MEMORANDUM

SUBJECT: **Engineering Review 1**
Preliminary & Final Amended Major Site Plan
Hopewell Parc Apartments – Phase 1N-4
1 SP Drive Owner Urban Renewal LLC
Block 93.06 Lots 81 & 83, IMF-1 Zone
Hopewell Township, New Jersey
FEI Project No.: 23HT205

Re: **Engineering Review 1**

TITLE
MULTIFAMILY CLUBHOUSE
FLOOR PLAN

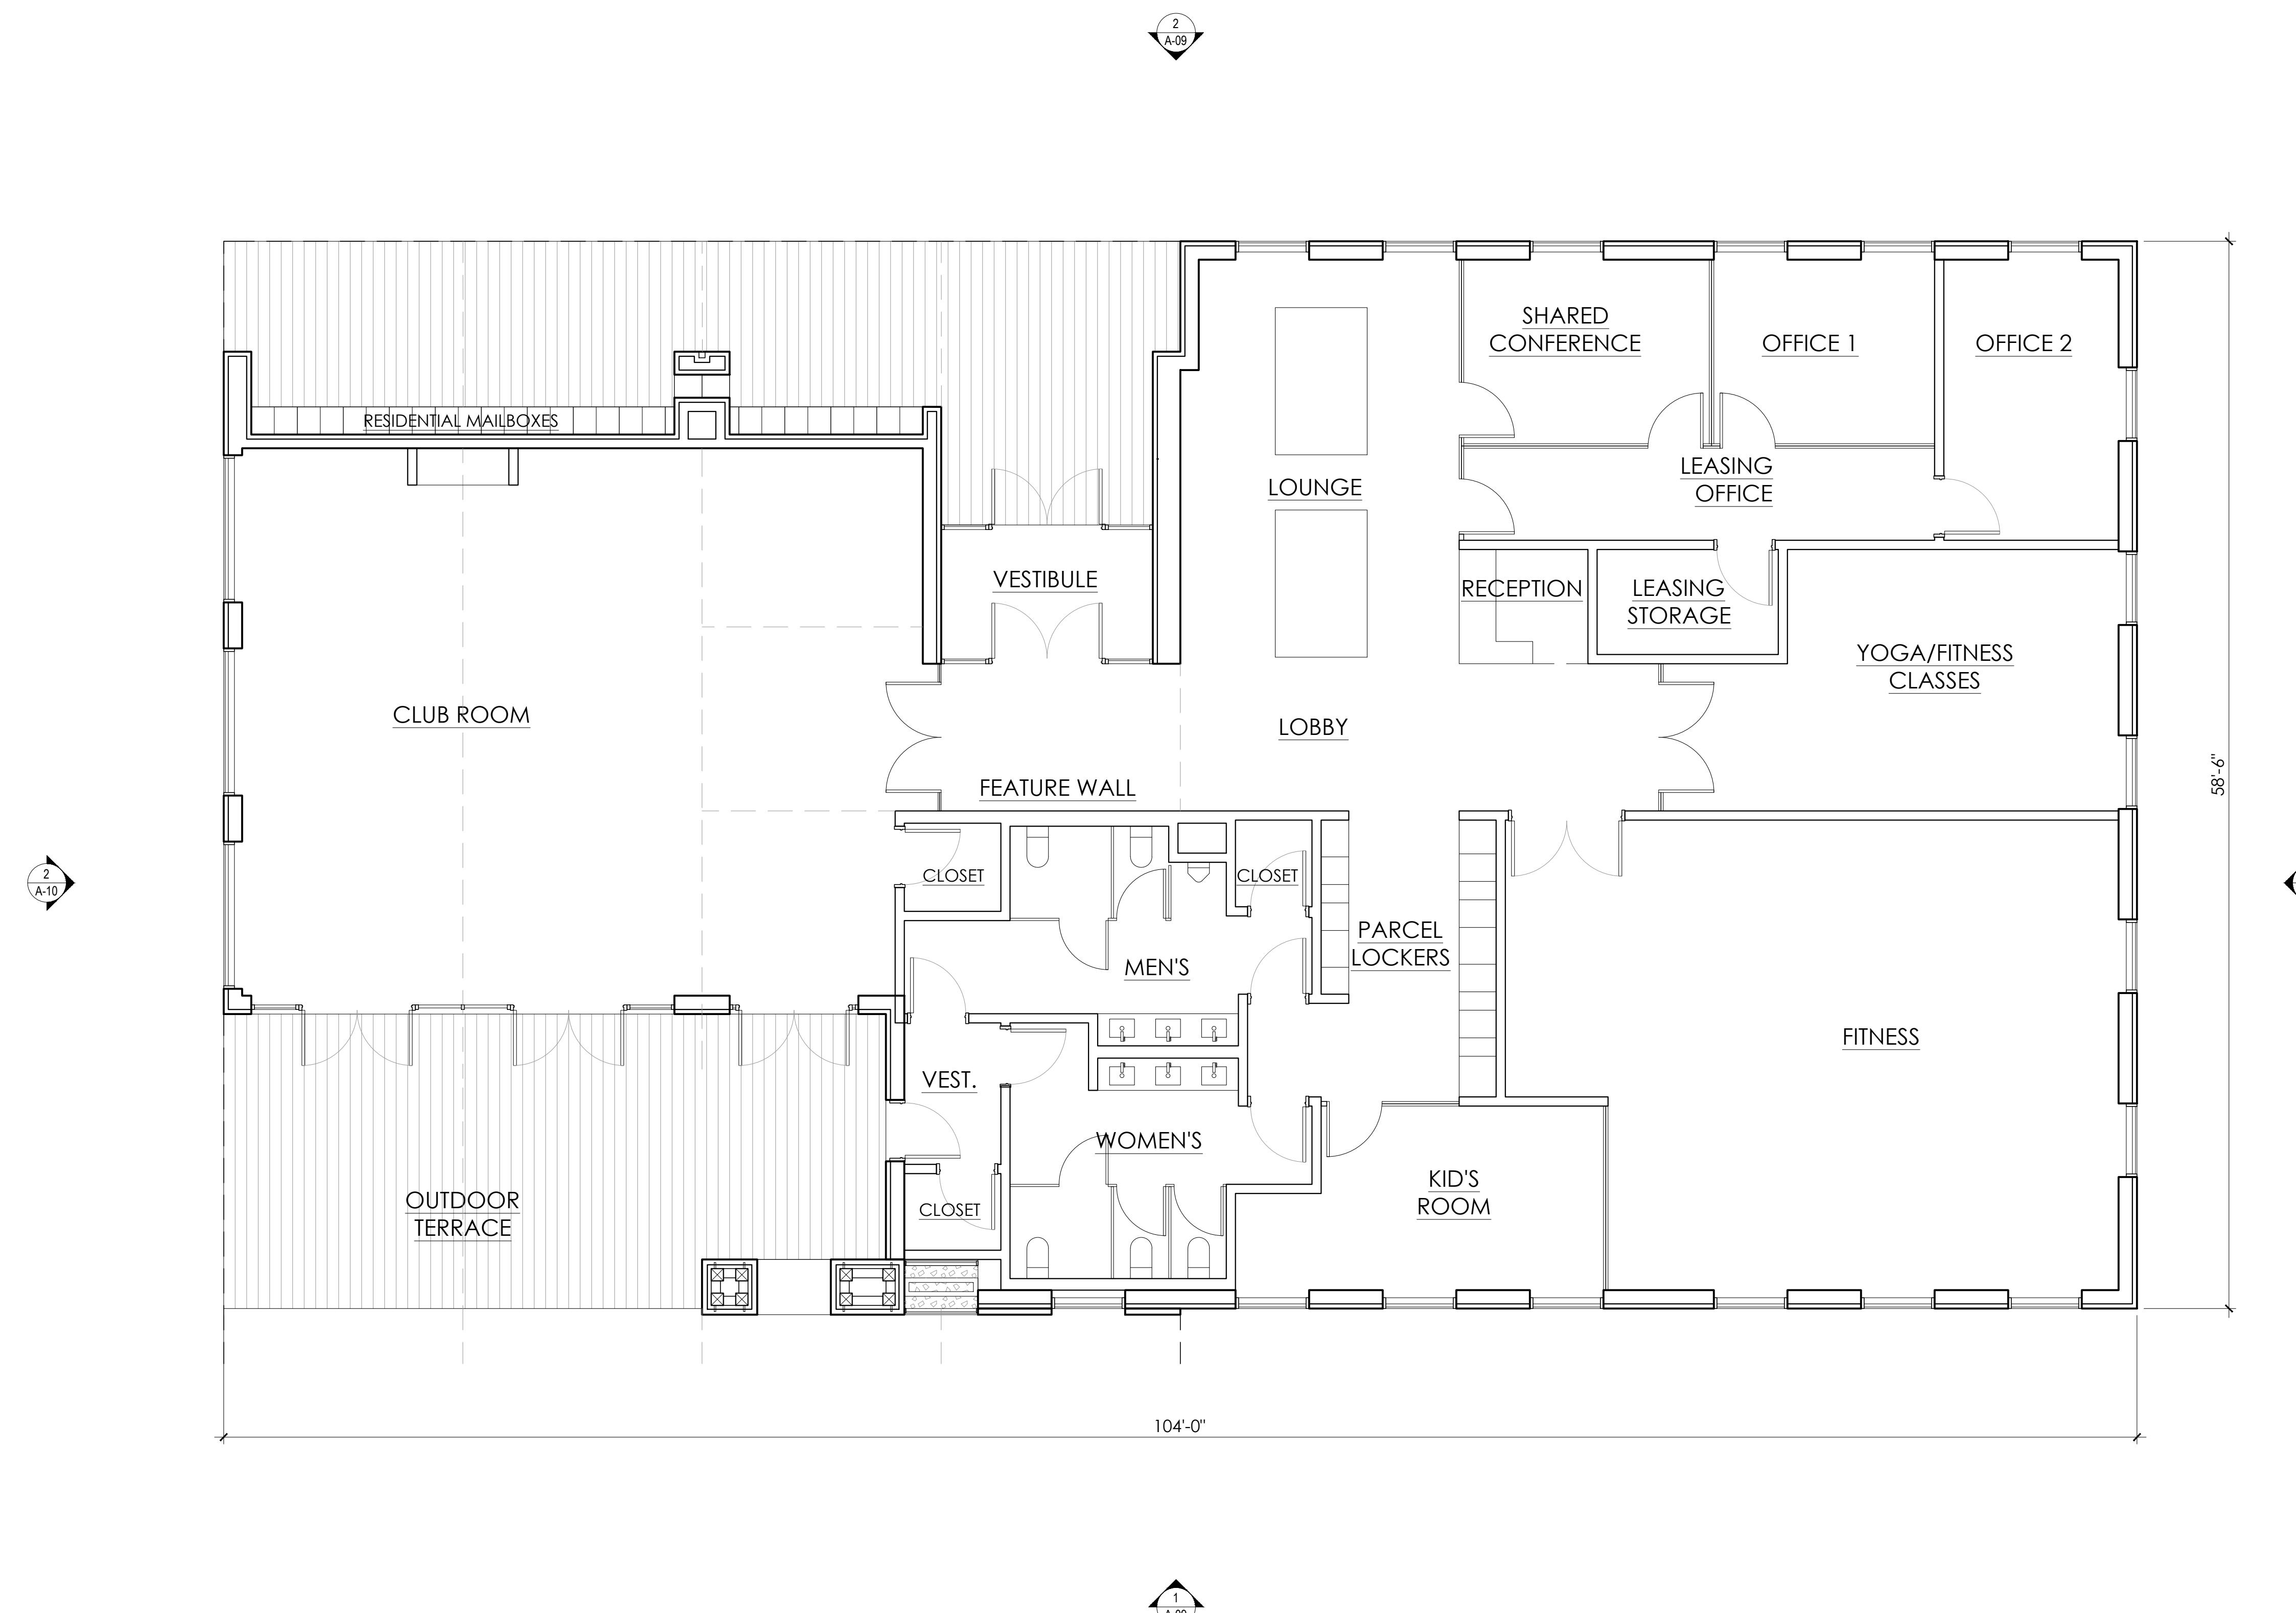
The redeveloper has proposed minor changes to the proposed clubhouse building for the apartment development, based on a refinement of the program for the amenities building. Attached for reference are marked-up copies of Sheet A-08 from the architectural plans, prepared by Major Architecture, DPC, and submitted with the plans approved by the Planning Board that illustrate the proposed changes.

The redeveloper has proposed modifications to the building footprint and outdoor areas that result in an increase in the building area of approximately 181 square feet, and a comparable reduction in the covered outdoor areas contained within the building footprint. The overall footprint/roof area is also proposed to be reduced by approximately 129 square feet to reflect a recess in the façade and roof at the rear of the building.

- a. The reduction in the building footprint / roof area is *de minimis* in nature and will not have a material effect on the overall project development. The reduction in the proposed impervious cover is nominal and the footprint alteration does not require any subsequent changes to the site plan approved by the Planning Board.

- b. The increase in the building footprint would ordinarily require approval by the Planning Board, as indicated in §17-29.b(ii), which stipulates that Site Plan approval is required for "*the alteration of a structure which would increase the total floor area or any outside dimension of the structure*". However, in this case, I recommend amended site plan approval is not required based on the following:
